AMENDMENTS TO THE DRAWINGS

U.S. Appl. No. 10/565,802
13415/202011

Appl. No. 10/565,802
Reply to Office Action dated 1.04.07
Annotated Sheet Showing Changes

FIG. 5

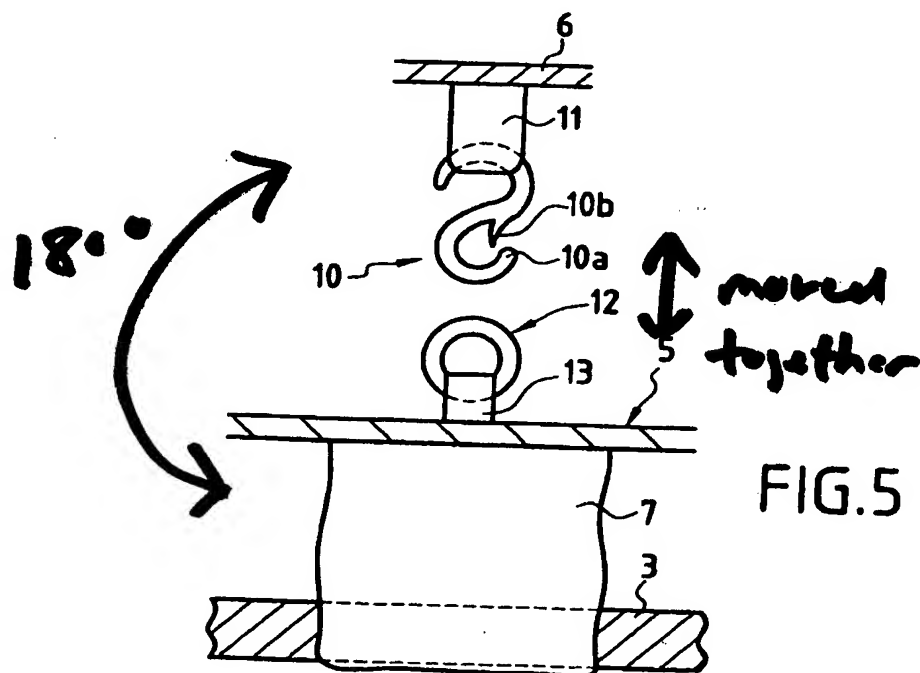
The attached sheet of drawings includes changes to Fig. 5. This sheet, which includes Fig. 3-5, replaces original sheet including Fig. 3-5. In Figure 5, the two parts have been connected together and the figure has been turned 180 degrees to be consistent with the other drawings.

In amended FIG. 5, the two parts have been connected together and the figure has been turned 180 degrees to be consistent with the other drawings. Accordingly, the Applicant respectfully submits that the drawing objections are obviated.
